SUNDRY NOTICES AND REPORTS ON WELLS

1. oil ☐ well gas ☒ well other ☐
2. NAME OF OPERATOR
Marathon Oil Company
3. ADDRESS OF OPERATOR
P.O. Box 2659, Casper, Wyoming 82602
4. LOCATION OF WELL (REPORT LOCATION CLEARLY. See space 17 below.)
1025' FNL&1050' FEL, Unit A
AT SURFACE:
AT TOP PROD. INTERVAL:
AT TOTAL DEPTH:
16. CHECK APPROPRIATE BOX TO INDICATE NATURE OF NOTICE, REPORT, OR OTHER DATA

(other) ☐ Change in dedicated acreage
on surveyors plat

Operator MARATHON OIL COMPANY			Lease OHIO "C" GOVERNMENT		Well No. 2-E
Unit Letter A	Section 26	Township 28N	Range 11W	County San Juan	
Actual Footage Location of Well: 1025 feet from the North line and 1050 feet from the East line					
Ground Level Elev. 5709	Producing Formation Dakota		Pool Basin Dakota		Dedicated Acreage: 320 Acres

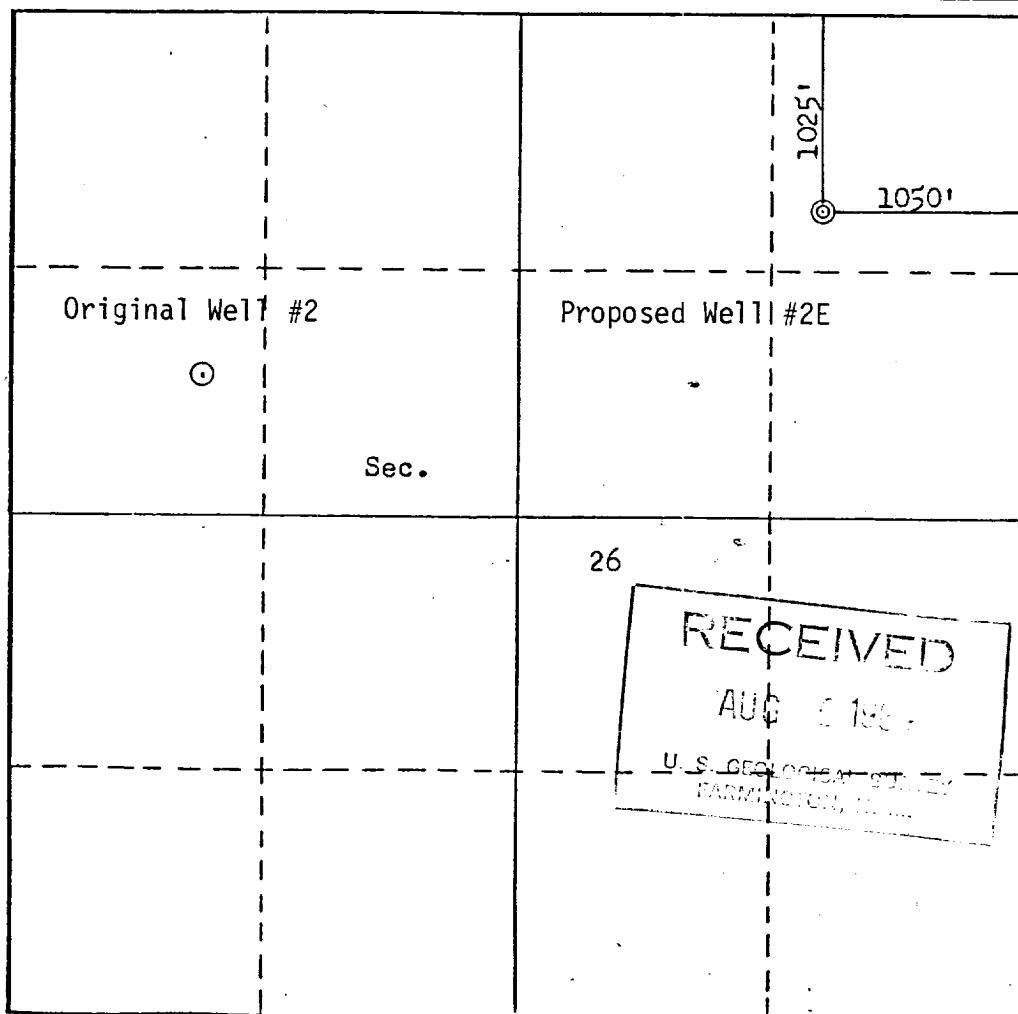
Attached are the corrected surveyors plat showing the original Well #2, proposed Well #2E, and 320 acre outline of the dedicated acreage, marked in yellow.
